ADDENDUM NUMBER 4

MILWAUKEE COUNTY  
WAR MEMORIAL – ART MUSEUM  
HVAC IMPROVEMENTS  
Site #265, Bldg. #40  
750 North Lincoln Memorial Drive  
Milwaukee, WI 53202

Project Number: O517-14629

Date of Addendum: January 21, 2015

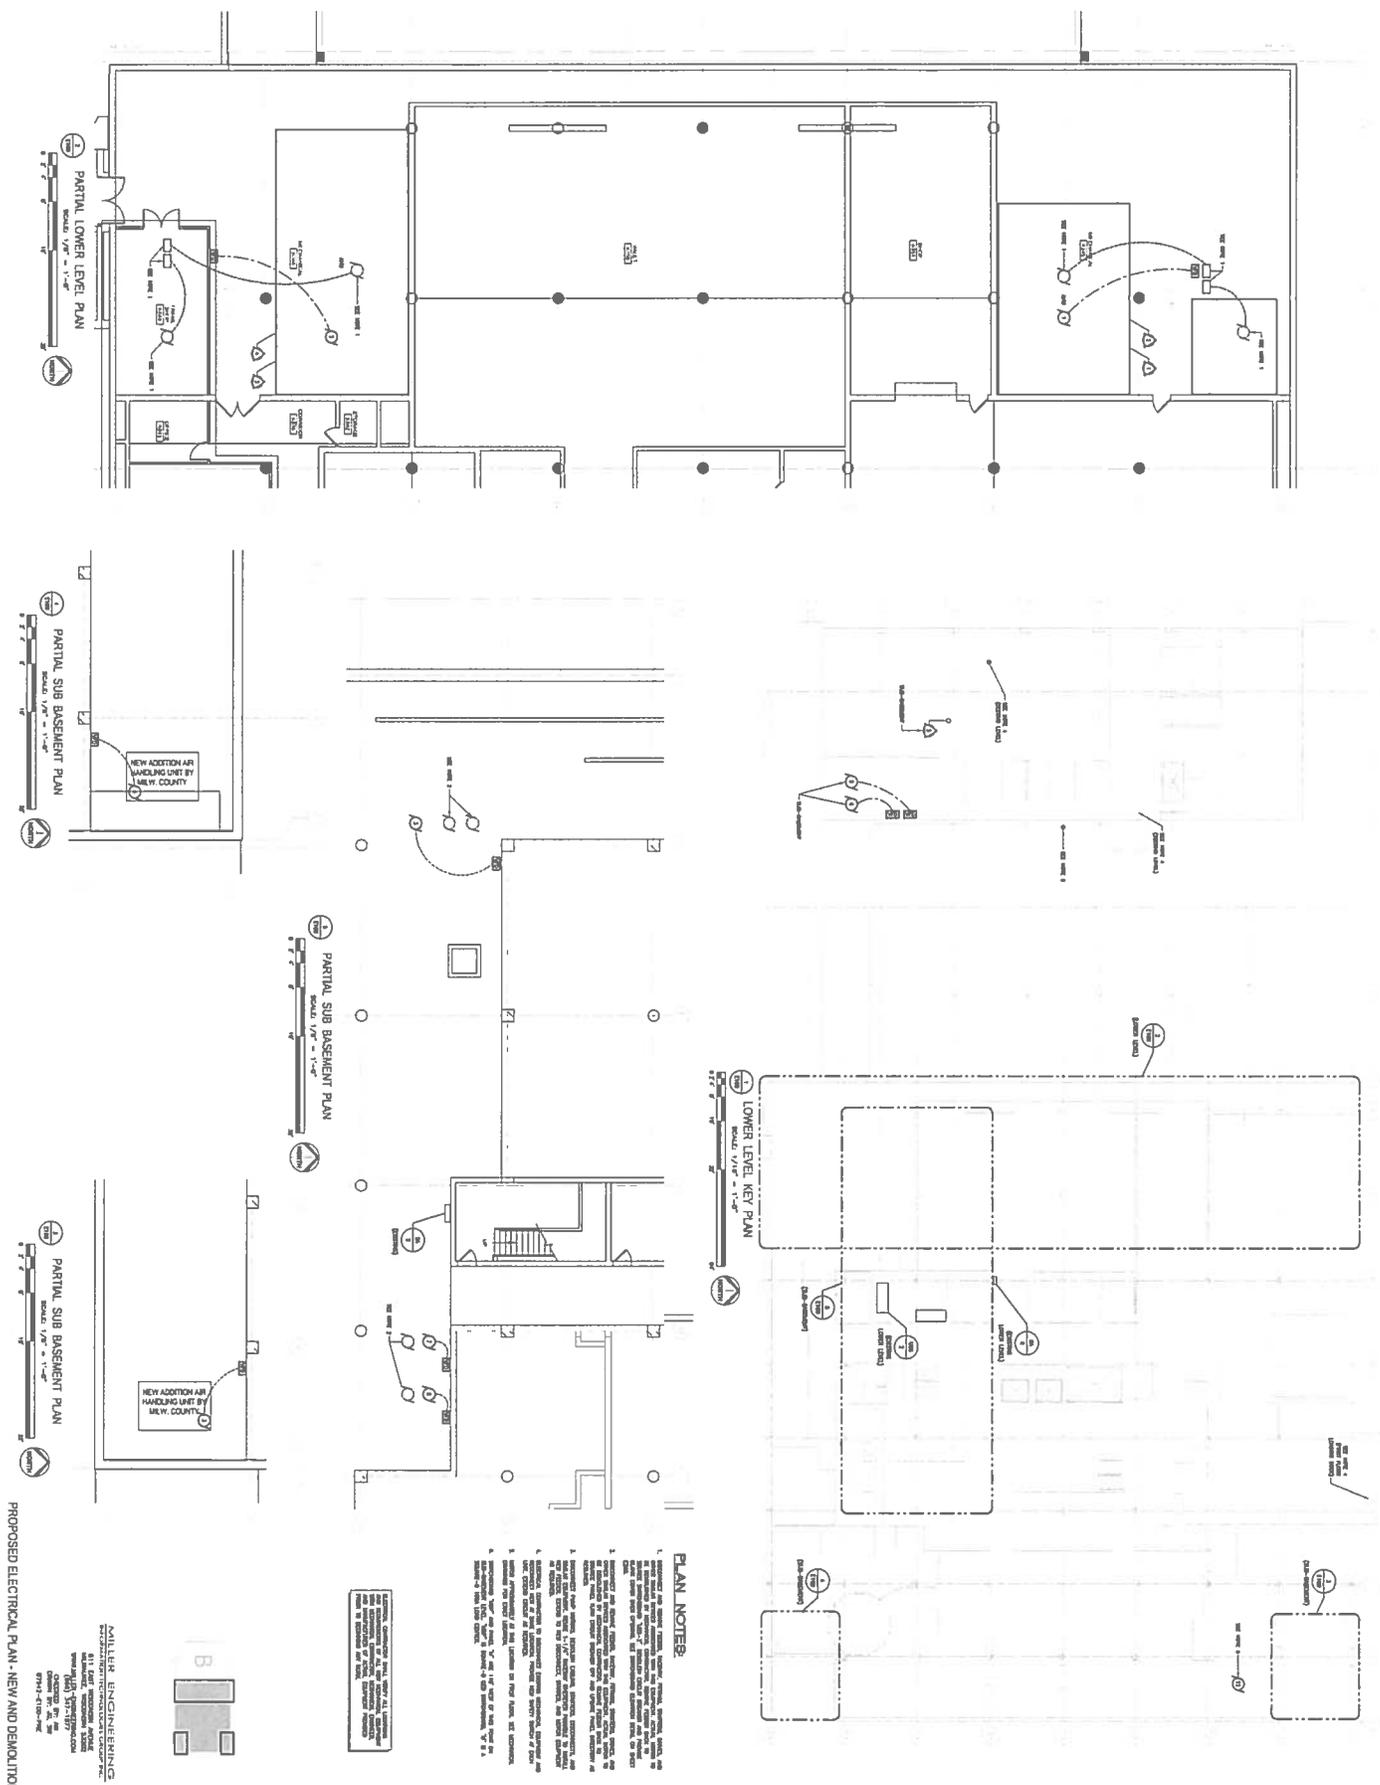
- a. Amiad Water Systems
    - i. MAP-200 with 3,500 micron perforated 316 stainless steel screen.
    - ii. MAP-200-RL, 8" 800GPM each.
    - iii. AML3 PLC control panel for dual filter control.

Unit is designed for horizontal installation and service.
